**OHIO TURNPIKE AND  
INFRASTRUCTURE COMMISSION**

**ADDENDUM NO. 1**

**PROJECT NO. 43-19-04**

BRIDGE DECK REPAIR AND REHABILITATION  
RIVER ROAD (T.R. 126) OVER OHIO TURNPIKE M.P. 120.0,  
WIKEL ROAD (T.R. 127) OVER OHIO TURNPIKE M.P. 121.9,  
CHAPIN ROAD (T.R. 131) OVER OHIO TURNPIKE M.P. 123.1,  
STATE ROUTE 60 OVER OHIO TURNPIKE M.P. 131.6,  
GIFFORD ROAD (T.R. 46) OVER OHIO TURNPIKE M.P. 135.4  
ERIE AND LORAIN COUNTIES, OHIO

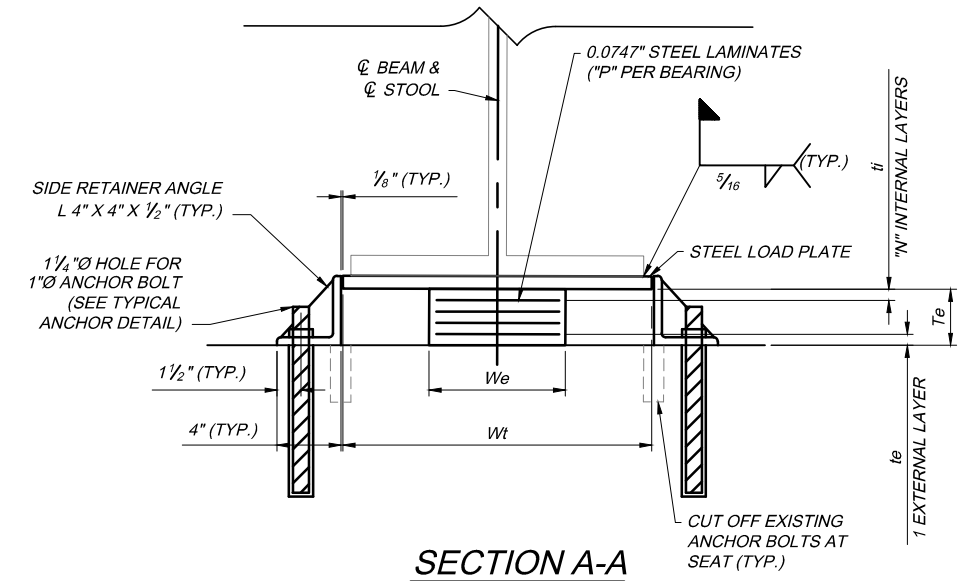
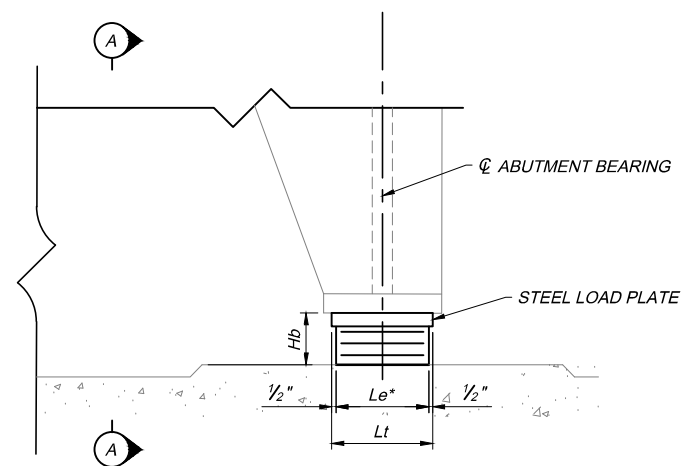
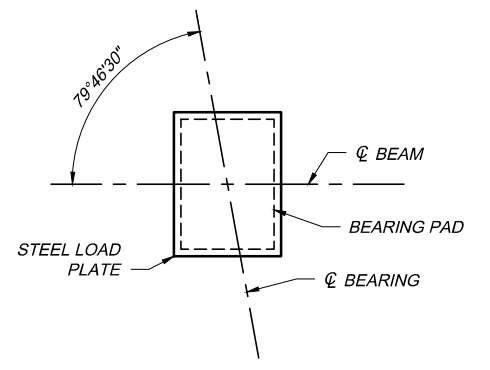
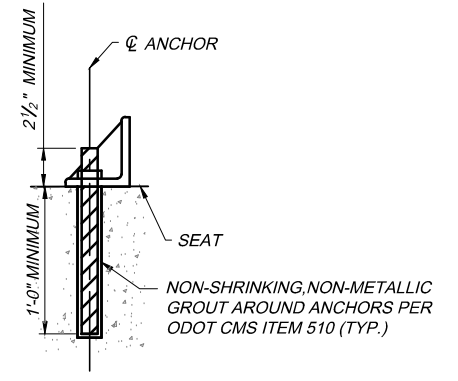
**Q#2** Note 4 on sheet 22/74 and 69/74 say to see item SP 514A for payment for painting of the bearings. Item SP 514A does not exist. How will painting of the bearings be made and paid for?

*A#2 Painting of the bearings (and associated items specified in the plans) shall be considered incidental to the bearing pay item(s). Plan Sheet Nos. 22 and 69 of 74 are revised through this Addendum No. 1 to reflect this clarification.*

4. THE STEEL LOAD PLATE, SIDE RETAINER ANGLES AND PEDESTALS SHALL BE ASTM A709 GRADE 50 STEEL AND SHALL BE PAINTED IN ACCORDANCE WITH SP 514A. PAINTING SHALL NOT BE PAID FOR DIRECTLY, BUT SHALL BE CONSIDERED INCIDENTAL TO THE ITEM.
